RE: Norfolk Southern Pittsburgh Vertical Clearance Project (the Railroad Project), Determination of Effects Report (December 2022; Effects Report) prepared for Norfolk Southern Railway Company, by Michael Baker International, Inc

Determination of Effects Report (December 2022) Response

RE: ER Project # 2018PR13984.021, NORFOLK SOUTHERN PITTSBURGH VERTICAL CLEARANCE,
Department of Transportation (PennDOT), Pittsburgh City, Allegheny County

Diagram 3:
Alternate 2A Refined

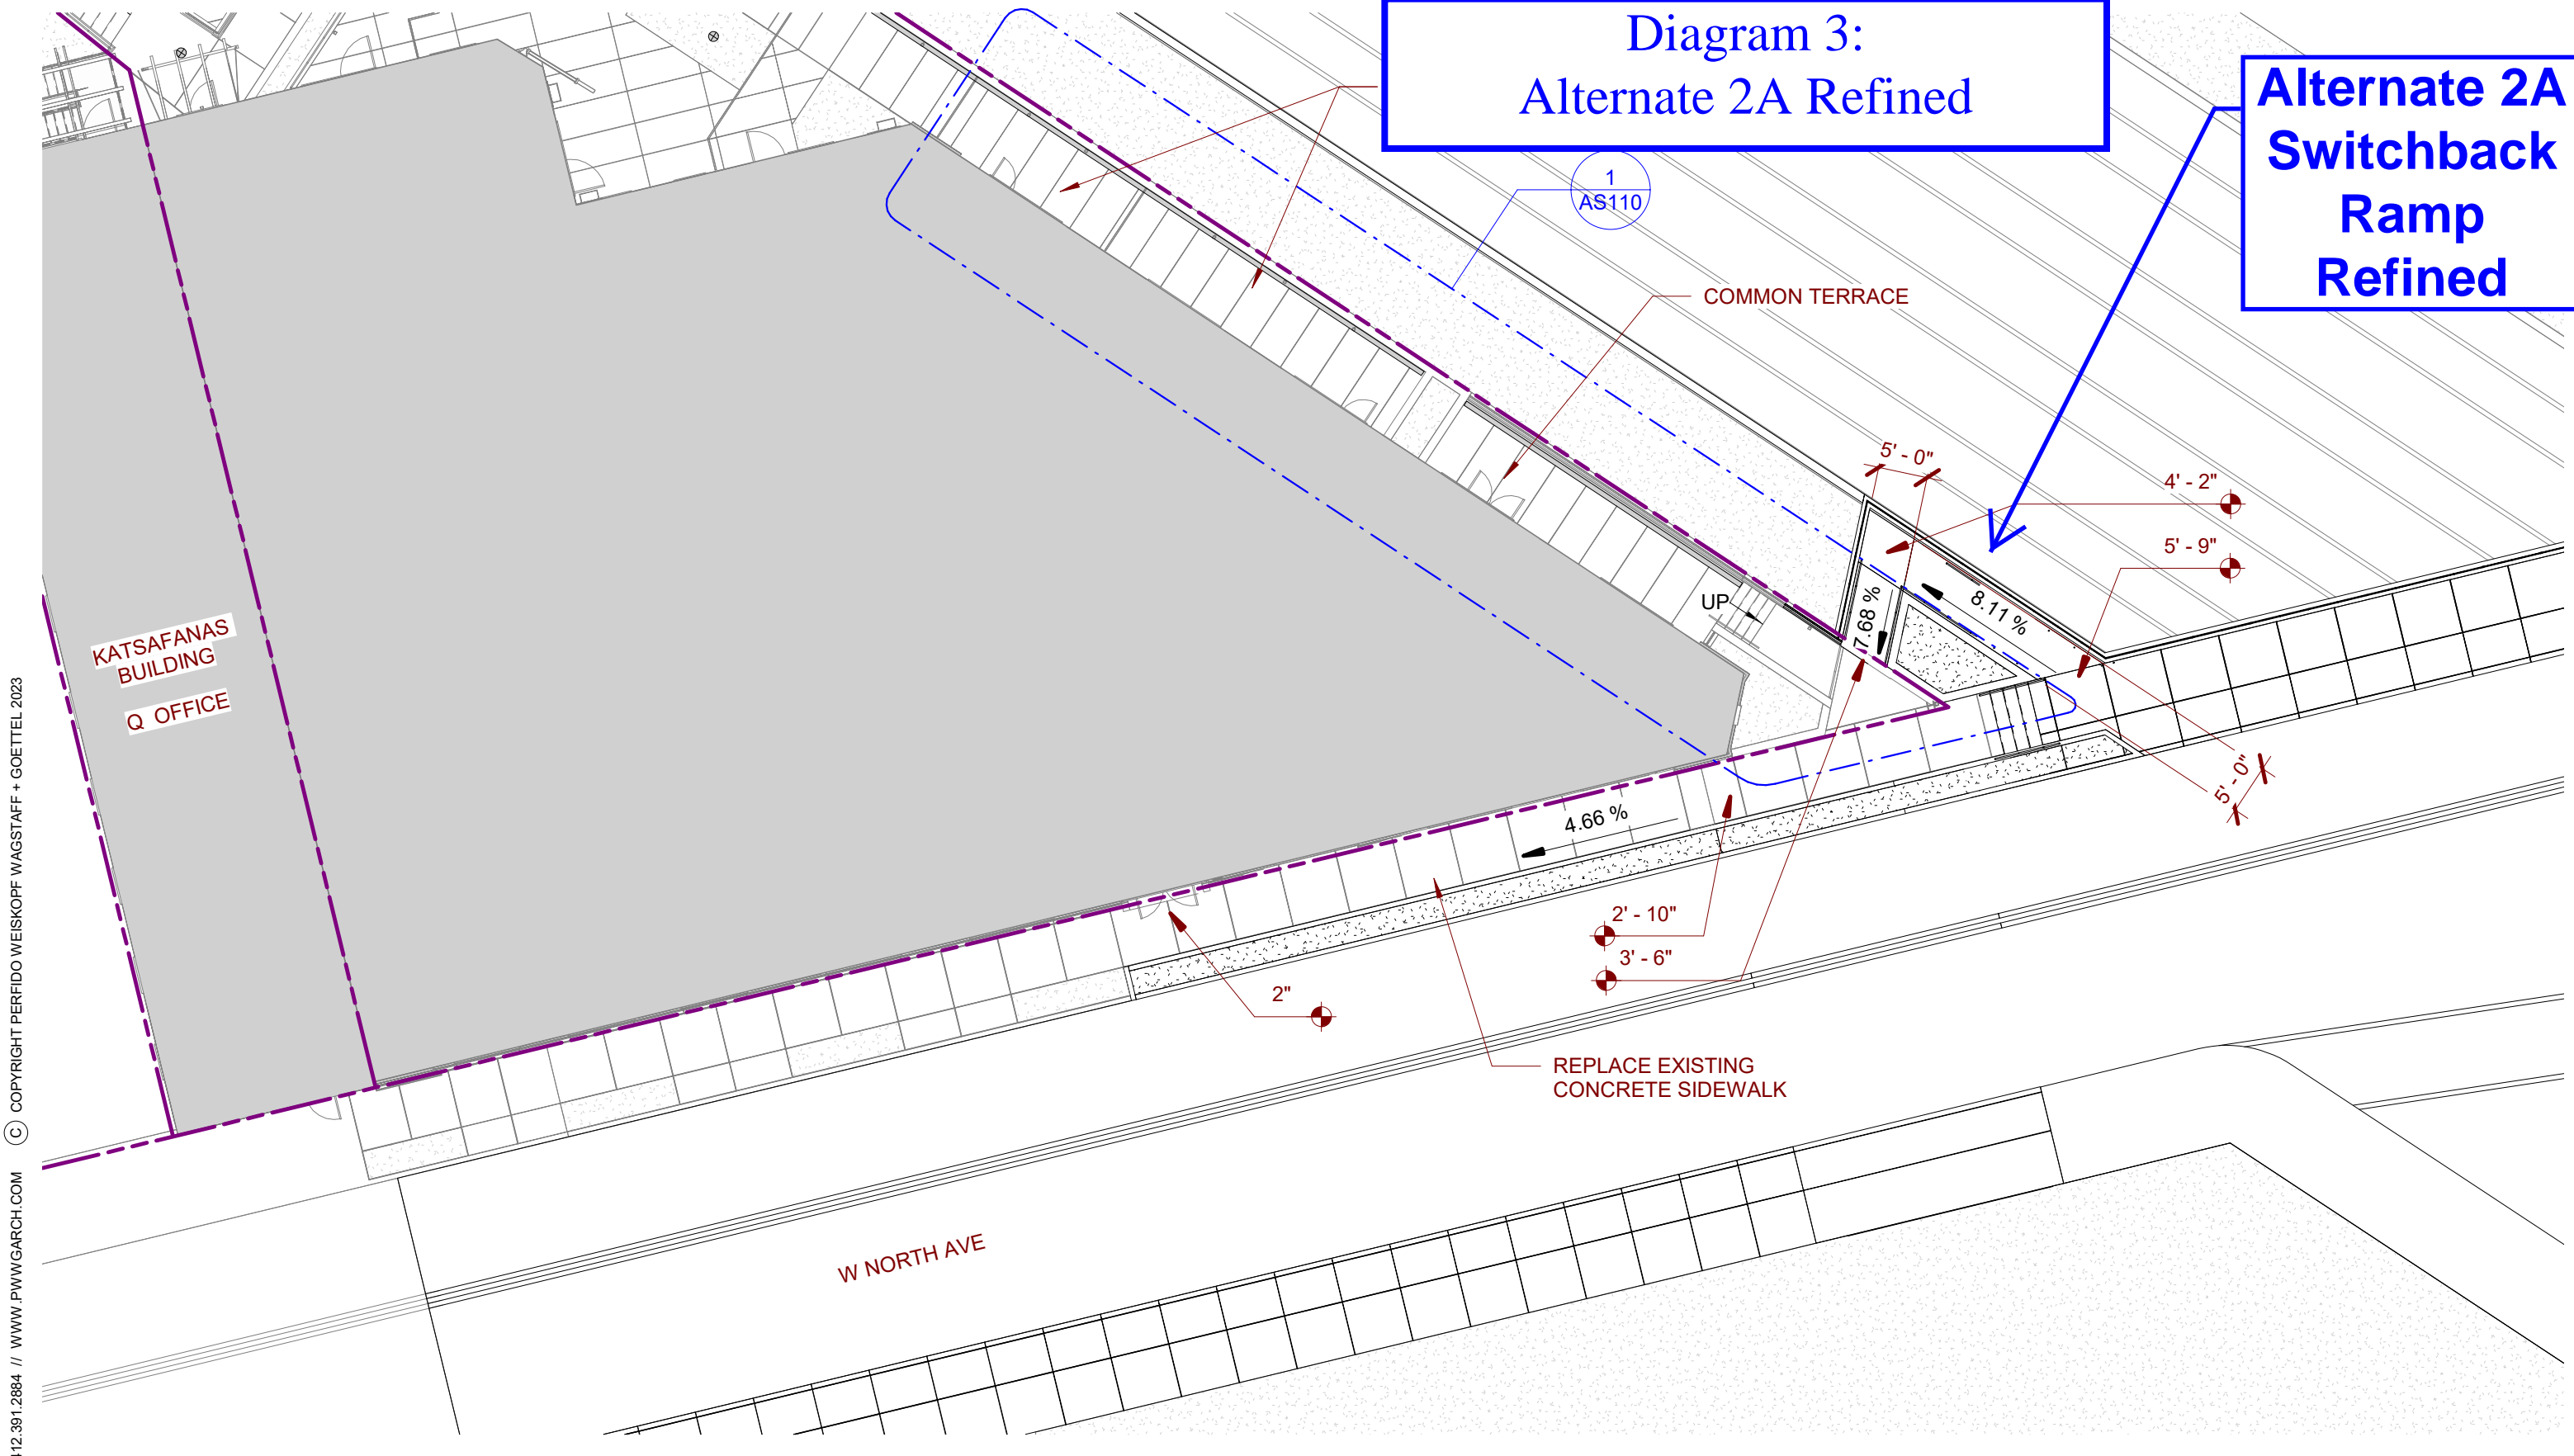
The Q Development team has reviewed Alternate 2A and has proposed modifications to further minimize the potential Adverse Effects (Rendering 1 and Diagram 3 attached). These refinements accomplish:

- ❖ Provide ADA accessibility via the switchback ramp with slope reduced from three 8.3% sections to one 8.1% and one 7.7% sections;
- ❖ The switchback ramp allows the balance of the sidewalk plan to fit within the 95’ sidewalk distance to the front door, contrary to the Preferred Alternative;
